UNITED STATES
NUCLEAR REGULATORY COMMISSION
WASHINGTON, D. C. 20555

February 3, 1992

Docket No. 52-002

APPLICANT: Combustion Engineering, Inc. (CE)
PROJECT: CE System 80+
SUBJECT: SUMMARY OF MEETING ON DECEMBER 4, 1991, REGARDING SYSTEM 80+ HUMAN FACTORS ISSUES

Figure 1

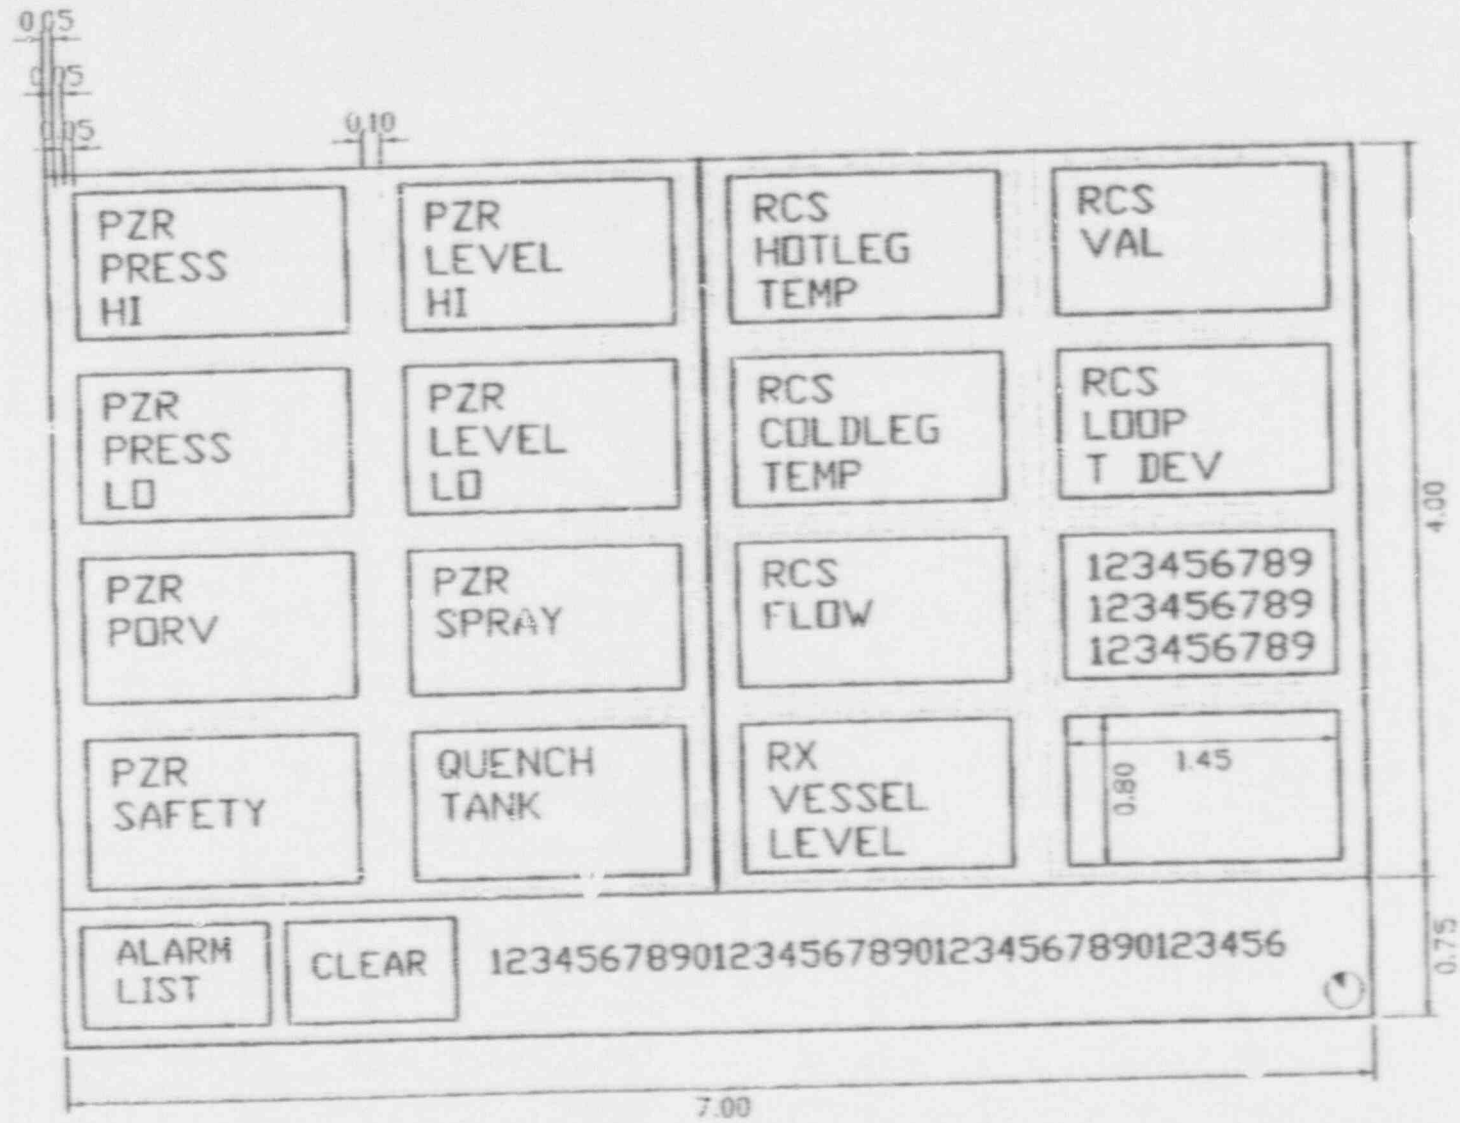
Among comments received on the draft HFE Standards & Guidelines was the concern that the generic standard proposed for text size (i.e., visual angle equal to at least 15 minutes-of-arc at the designer's defined reading distance) was too restrictive. Rather than justify the NPX80+ design's departure from the standards, additional standards will be provided and the guidance adjusted as follows.

Generic touch target features (e.g., a "clear" button), alarm messages, diagnostic-level detail, etc. should continue to use the standard for "at the panel" display. Figure 1 shows the use of .125 inch and .14 inch text for a DIAS alarm window, approximately to scale. Note that the printout resolution vastly exceeds that of the actual EI display.

The guidance ("should") will become 16 minutes-of-arc.

The standard ("shall") will become 12 minutes-of-arc.

In addition, .14 inch text is identified as a defensible compromise between the .125 inch and .175 inch text sizes that satisfies MFE bases (most importantly, that .14 inch text read from 50 inches is not anti-limiting; see Item 2 under Bases, below) as well as existing constraints on the size and resolution of the DIAS electro-luminescent (EL) displays. Use of the .14 inch text size should be considered where:

All window tile text is .14 in high.
 Message and 'touch button' text
 below the tile array is .125 in high.
